METROPOLITAN GOVERNMENT OF NASHVILLE AND DAVIDSON COUNTY

Metropolitan Historic Zoning Commission
Sunnyside in Sevier Park
3000 Granny White Pike
Nashville, Tennessee 37204
Telephone: (615) 862-7970
Fax: (615) 862-7974

STAFF RECOMMENDATION 515 Fatherland Street February 20, 2013

Application: New construction-primary structure
District: Edgefield Historic Preservation Zoning Overlay
Council District: 06
Map and Parcel Number: 08215020600
Applicant: Peggy Newman
Project Lead: Melissa Baldock, melissa.baldock@nashville.gov

515 FATHERLAND STREET SITE PLAN
 SCALE 1" = 20'-0"

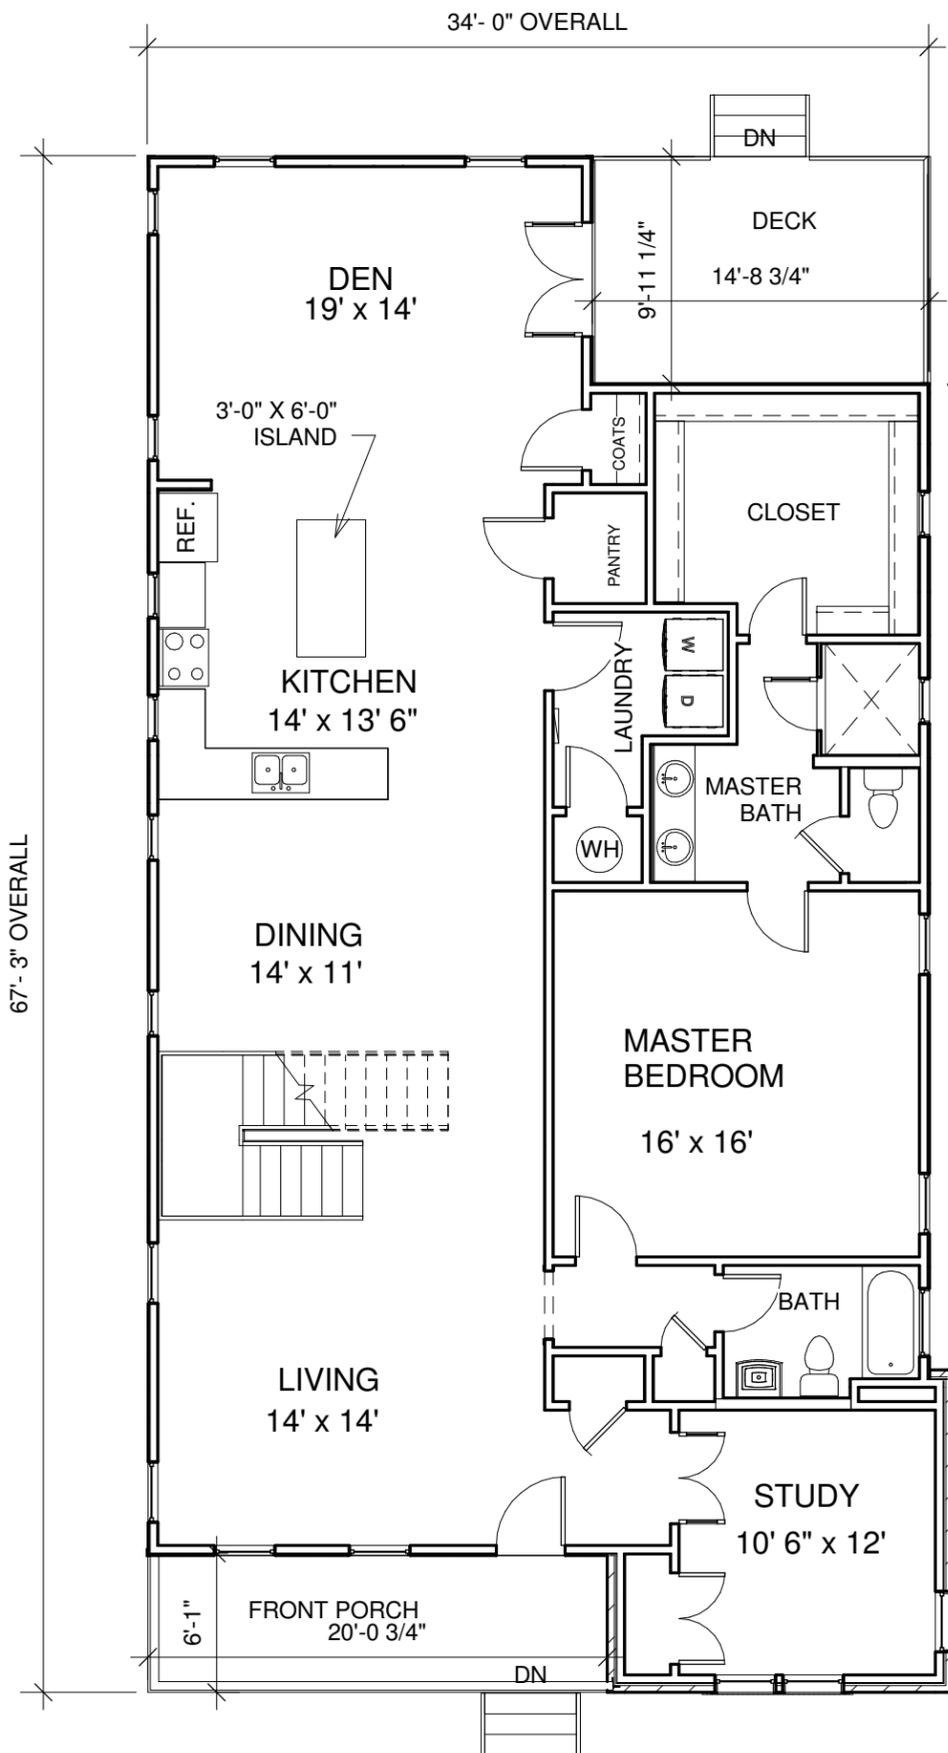
Fences: No fences were called out on the site plan, and staff reminds the applicant that in the Edgefield Historic Zoning Overlay, all fences must receive a preservation permit.

Permanent Built Landscape Features & Public Space: The applicant is proposing a central walkway leading from the sidewalk to the front porch, which is appropriate. Another walkway will be installed in the rear, leading from the deck to a new parking pad. Staff finds these landscape features to be appropriate, and asks to review the

walkway and parking pad material prior to installation. No other lighting, walkways, walls, or other appurtenances were indicated on the drawings, and staff asks to review and approve any new appurtenance. With the approval of the material, staff finds the walkways and parking pad to meet Sections IV.B.2. and IV.B.4. of the *Edgefield Historic Zoning District: Handbook and Design Guidelines*.

515 FATHERLAND FRONT ELEVATION
SCALE 1/8" = 1'-0"

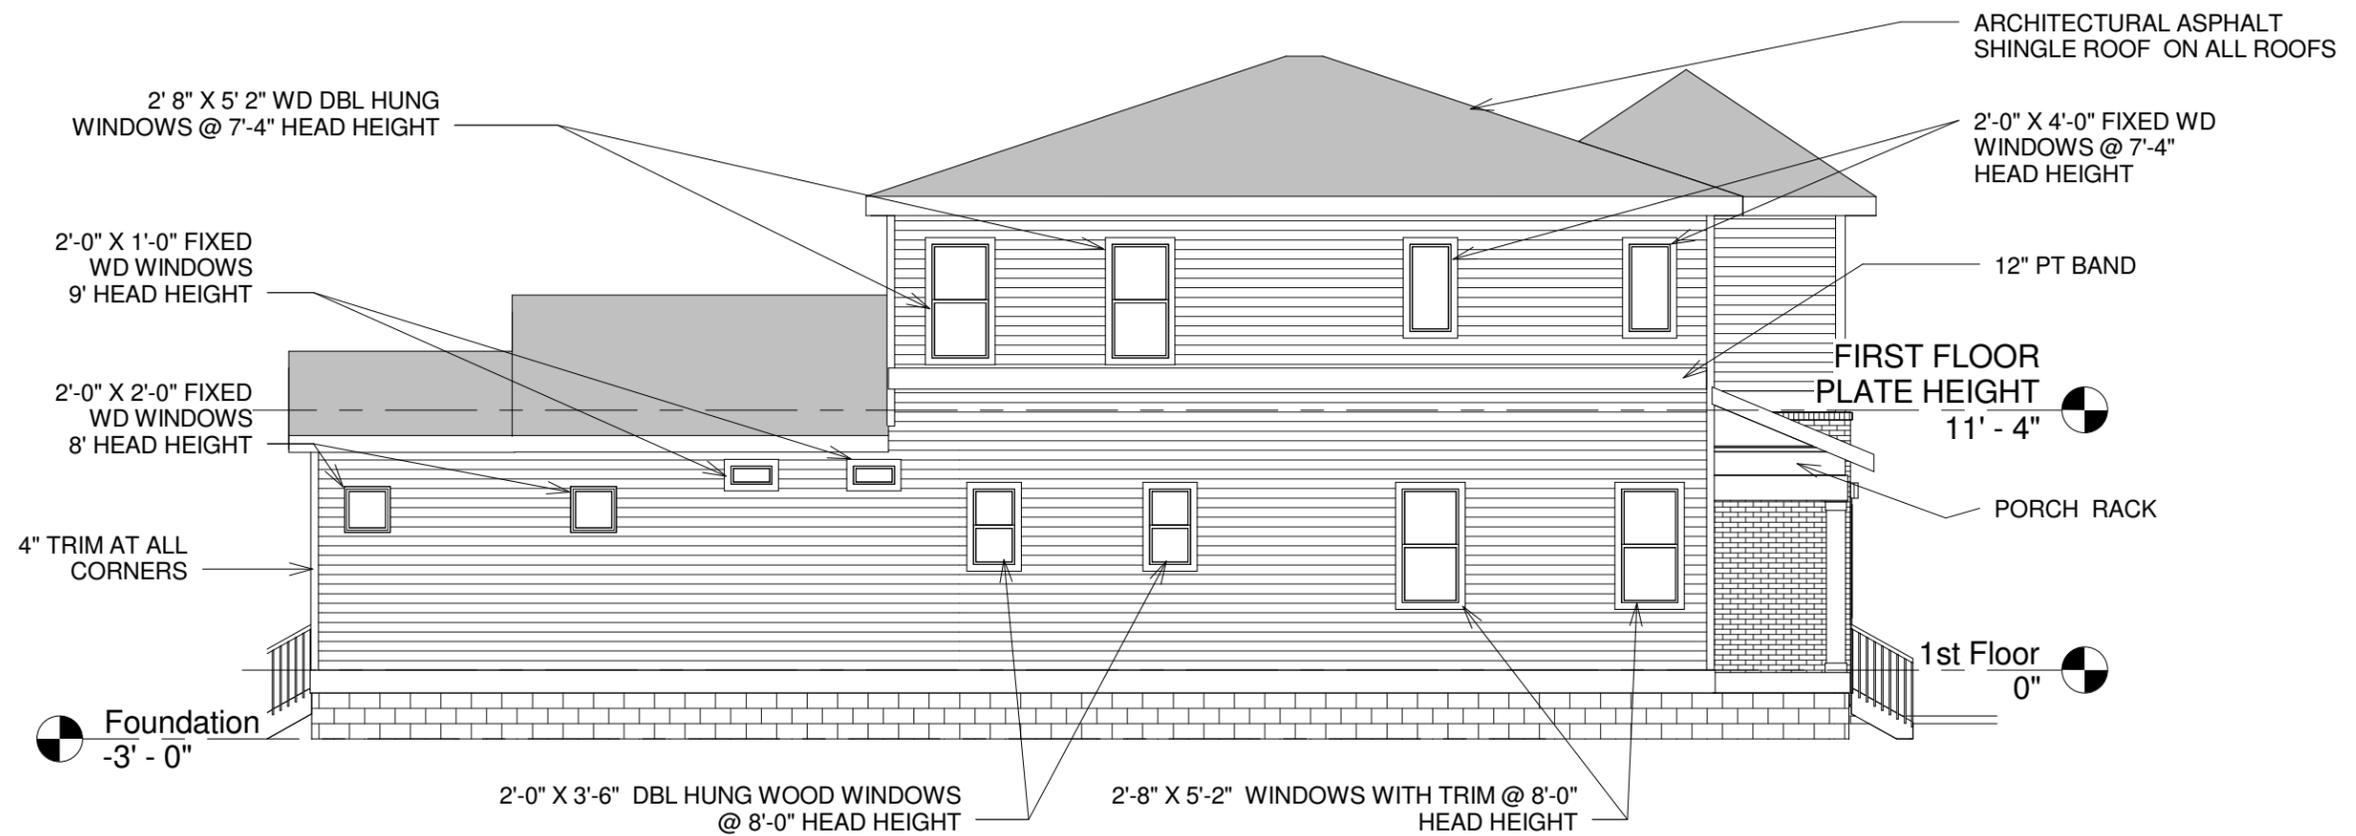
Height and Building Shape: The proposed structure will be a two-story gabled-ell. The maximum height of the structure is proposed to be twenty-six feet, ten inches (26' 10")

from the floor line, or approximately thirty feet (30') above grade. The height of the structure will be minimized by the hipped roof form, ensuring that the maximum height is not reached until twenty-three feet (23') behind the front wall of the house. The projecting bay portion of the structure will have a lower height. It will have a ridge height of approximately twenty-nine feet (29') from grade. Likewise, the rear of the structure will be lower in height, at only one story and between seventeen and nineteen feet, six inches tall (17' – 19'6"). Staff finds that the height of the structure is compatible with the historic structure across the street at 538 Fatherland, which is approximately thirty-feet (30') tall, but with a front gable so that the full height of the house is at the front wall.

Materials: While all of the known materials have been approved by the Commission in the past, their placement does not necessarily meet the design guidelines. The projecting bay will be brick on the ground floor, and staff asks to review a brick sample prior to purchase and installation of the material. Typically material changes happen at the floor level and continue on all elevations. In this case, brick is only on one level of the bay. Staff recommends that either the entire projecting bay be brick or the first level of the entire house be brick. The projecting bay will have five inch (5") cement fiberboard lap

siding at the second story level and the majority of the first story. The projecting bay will be separated from the rest of the house by being in different planes. The rest of the house will be clad in cement fiberboard siding with a five inch (5") reveal. The foundation will be split face concrete block, and the windows and doors will be wood. Staff asks to review and approve the window and door specifications prior to purchase and installation. The roof will be architectural asphalt shingles, and staff asks to review and approve the shingle color. The materials for the front porch steps, porch floor, and porch columns were not specified, and staff asks to approve them prior to purchase and installation. Similarly, the material for the rear deck and rear deck railing was not specified, and staff asks to approve the material.

Proportion and Rhythm of Openings: The windows at the front of the structure, and on the front half of the side facades are largely taller than they are wide, and meet the typical historic proportions for window openings. On the recessed portion of the house's front facade, the windows on the second story are shorter than the windows on the ground floor, which is appropriate. On the side facades, beyond the midpoint of the house, and on the rear facade, the window openings are smaller and less historic in proportions. Staff finds these window openings to be appropriate because they are not on a primary facade, and will be less visible since they are towards the back of the house. There are no large expanses of wall space without a window or door opening on the infill's facades. Staff finds that the window proportions and rhythm of openings meets Section III.B.2.f. of the *Edgefield Historic Zoning District: Handbook and Design Guidelines*.

1. Staff review and approve a brick sample; the windows and doors specifications; the asphalt shingle color; and the material for the porch steps, porch floor, porch columns, and rear deck and deck railing.
2. The utilities be placed in the rear of the house, or on a side façade, beyond the midpoint of the house.
3. Staff review and approve the walkway and parking pad materials.
4. Staff review and approve all appurtenances for the site, including, but not limited to, lighting, fencing, and other landscape features.
5. The projecting bay be entirely brick, the first level of the entire house be entirely brick, the entire home be brick, or the entire home have lap siding with a minimal five inch (5" reveal.)
